Submittal Data Sheet

Submittal #: 8A

Project Name: Irasburg IM Deck (46)

Description of Item: 507.11 Reinforcing Steel, Placement Drawings: Span 1 Curb Reinforcing Placement

DECK REINFORCEMENT PLAN - SPAN #1
CONTRACT DWG. REF. 19 OF 49

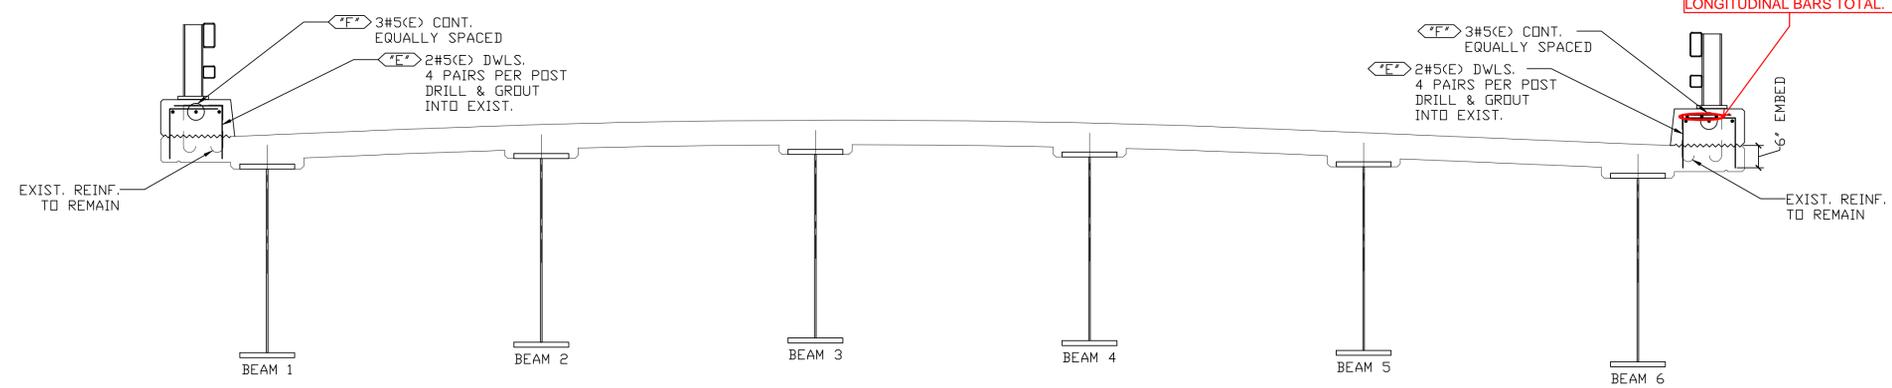
CURBS ARE BEING FULLY REPLACED. LONGITUDINAL CURB BARS SHOULD RUN THE FULL LENGTH OF THE SPAN. FROM PREVIOUS REBAR SUBMITTAL, USE 2X3 #5 X 30'-0" (E) + 3 #5 X 22'-7" (E).

CURBS ARE BEING FULLY REPLACED. LONGITUDINAL CURB BARS SHOULD RUN THE FULL LENGTH OF THE SPAN. FROM PREVIOUS REBAR SUBMITTAL, USE 2X3 #5 X 30'-0" (E) + 3 #5 X 22'-7" (E).
